TFL Pre-Application Discussions

As noted in the design development section of the D&A, discussions with TFL have been undertaken between May - July 2022 in which a number of key design issues were highlighted by the LU Engineer. Subsequently these issues have been addressed and the following sections identify what measures have been incorporated into the design to mitigate the issues raised.

Proposed new mixed used development, Pinner Road, Northwood, London, HA6 1DD

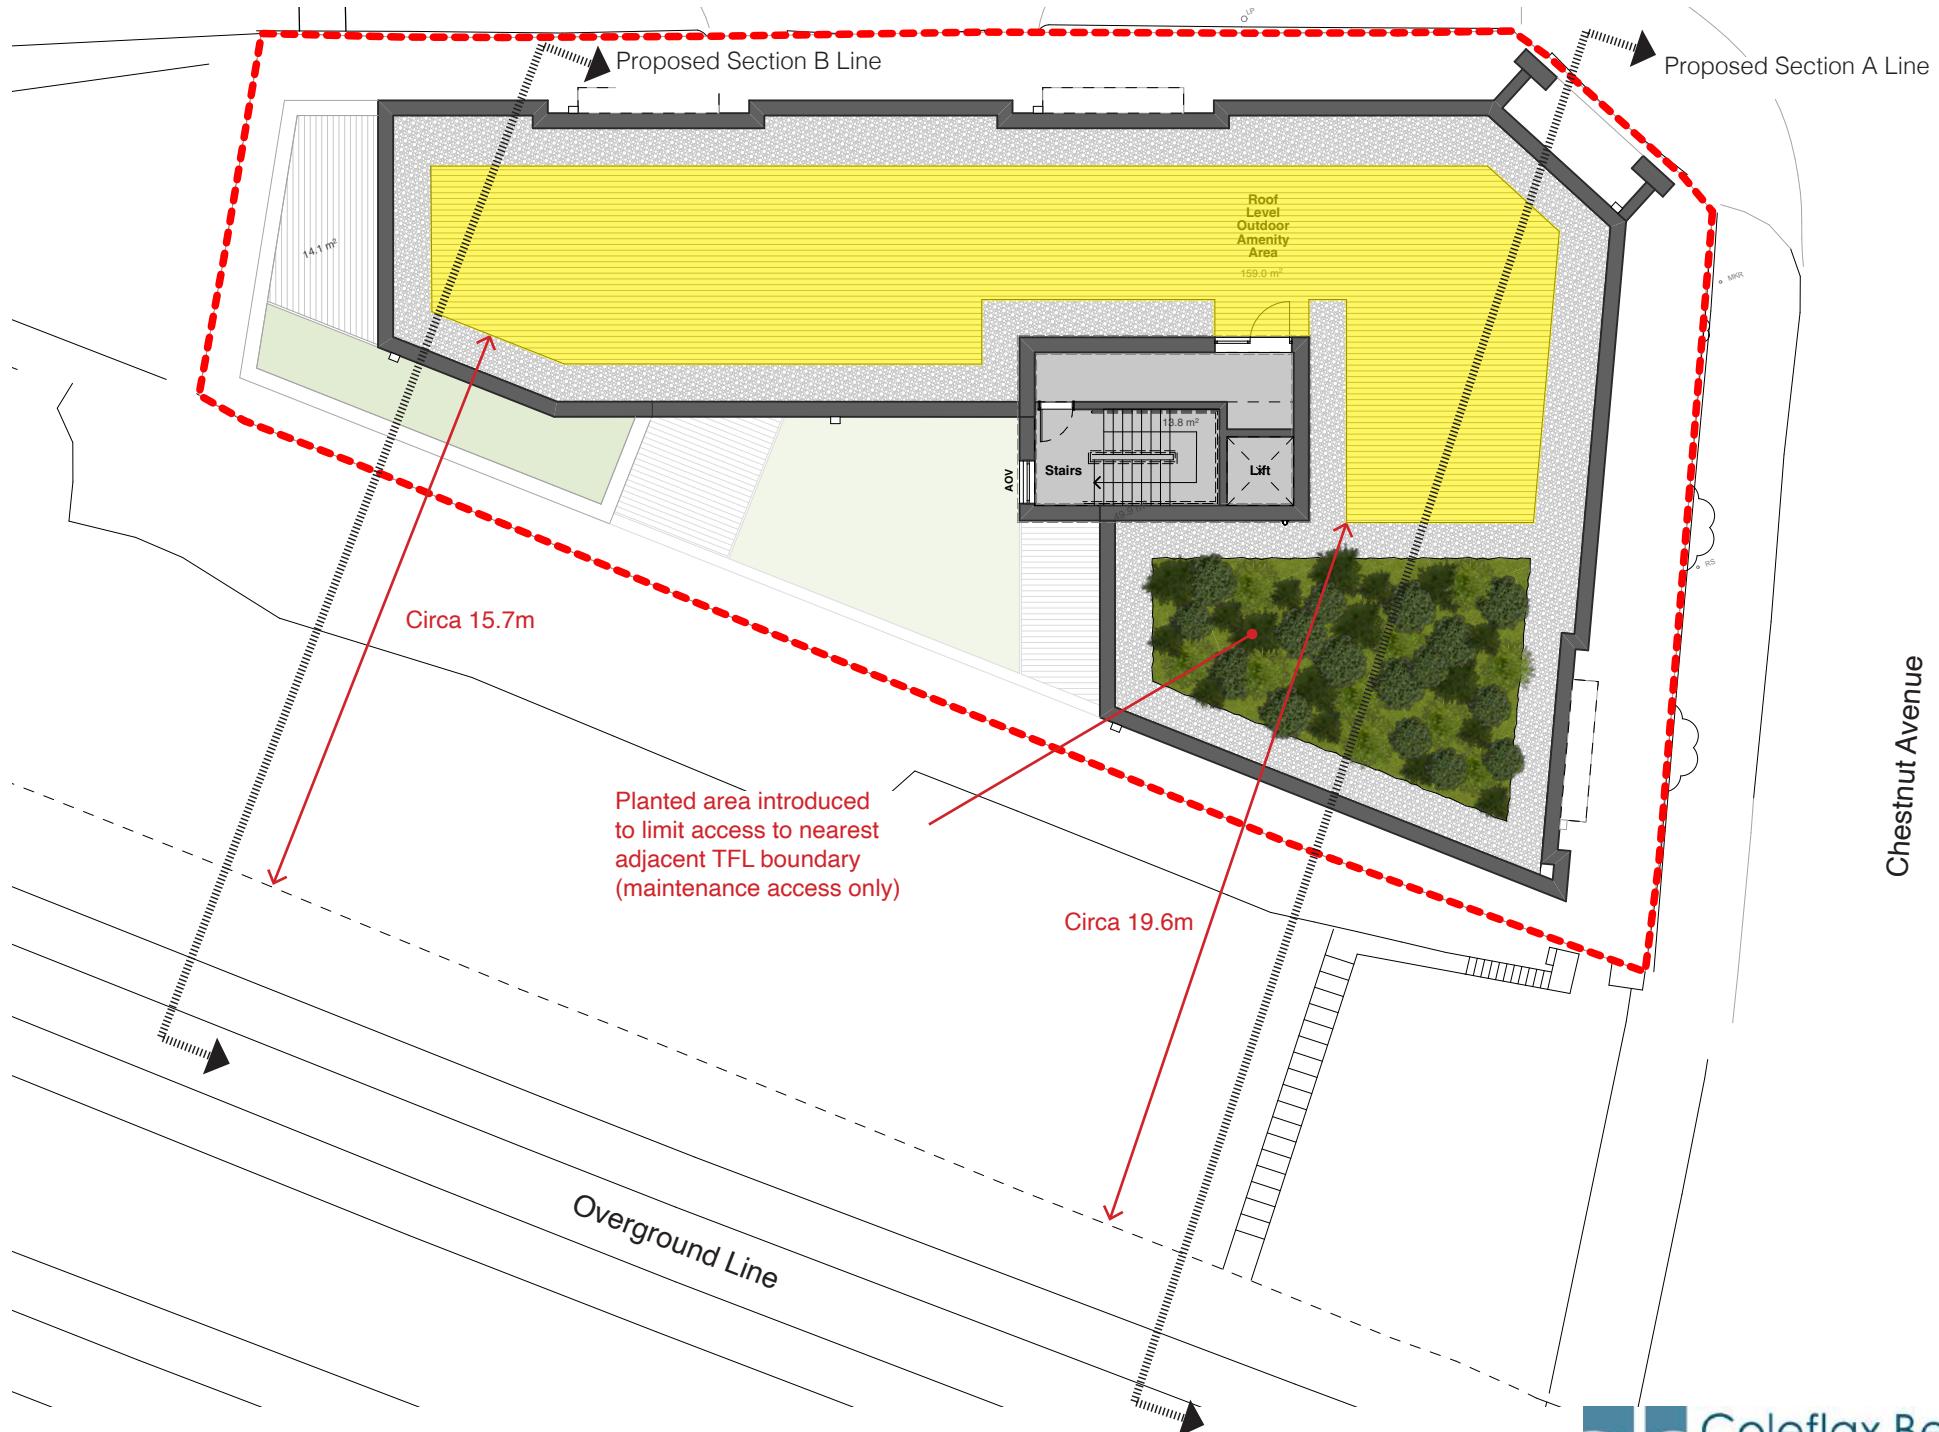
TFL Pre-Application Discussions

Planted area introduced to limit access to nearest adjacent TFL boundary (maintenance access only)

Circa 19.6m
